UNITED STATES PATENT AND TRADEMARK OFFICE

APPLICATION NO.	FILING DATE	FIRST NAMED INVENTOR	ATTORNEY DOCKET NO.	CONFIRMATION NO.
09/847,759	05/02/2001	Mark J. Hall	HANBEV.002RA	6043
20995 7590 07/07/2010 KNOBBE MARTENS OLSON & BEAR LLP 2040 MAIN STREET FOURTEENTH FLOOR IRVINE, CA 92614				
EXAMINER				
STRIMBU, GREGORY J				
ART UNIT		PAPER NUMBER		
3634				
NOTIFICATION DATE		DELIVERY MODE		
07/07/2010		ELECTRONIC

Office Action Summary

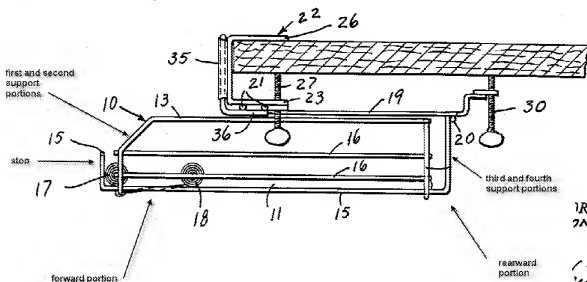
Claims 57, 59 and 61 are rejected under 35 U.S.C. 103(a) as being unpatentable over Dickson in view of Lockwood. Dickson discloses a shelf comprising:

a support assembly having a forward portion (labeled below) and a rearward portion (labeled below), the support assembly defining a support surface (not numbered, but shown in figure 3) configured to support a plurality of cylindrical beverage containers;

a stop (labeled below) disposed at the forward portion of the support assembly;
first and second support portions (labeled below) disposed at the forward portion of the support assembly, the first and second support portions including upper ends, respectively, adapted to be disposed above the plurality of cylindrical beverage containers supported on the support surface;

at least first and second apertures (not numbered, but comprising the apertures for the fasteners 27) disposed adjacent the upper ends of the first and second support

portions, respectively, the first and second apertures being configured to receive fasteners 27 for supporting the forward portion of the support assembly from a structure 32 above the support assembly, the first and second apertures being spaced rearwardly from the stop;

third and fourth support portions (labeled below) disposed at the rearward portion of the support assembly, the third and fourth support portions including upper ends, respectively;

at least a third aperture (not numbered, but shown as the aperture for the fastener 30 in figure 3) disposed adjacent the upper ends of the third and fourth support portions, respectively, the third aperture being configured to receive a fastener 30 for supporting the rearward portion of the support assembly from a shelf above the support assembly; and

wherein the third aperture is spaced from a rearward most portion 20 of the rearward portion of the support assembly such that cylindrical beverage containers can be placed onto the rearward portion of the support assembly when the third aperture is connected to a shelf disposed above the support assembly by fasteners;

a horizontally extending plate 35 (claim 61) having apertures in the plate which receive the wire 36. Dickson is silent concerning a panel and a fourth aperture.

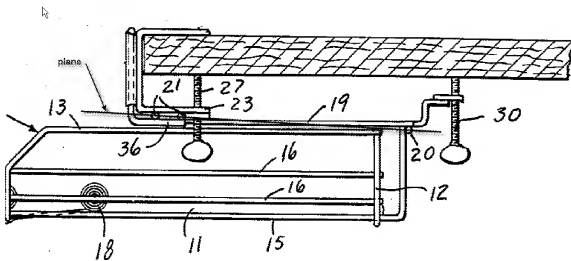
Regarding the applicant's comments concerning claim 56, the examiner respectfully disagrees. The rods 20, 21, 21 of Dickson define a plane since each of the rods defines a point and each of said points is in a plane as shown in the reproduction of figure 3 of Dickson below.
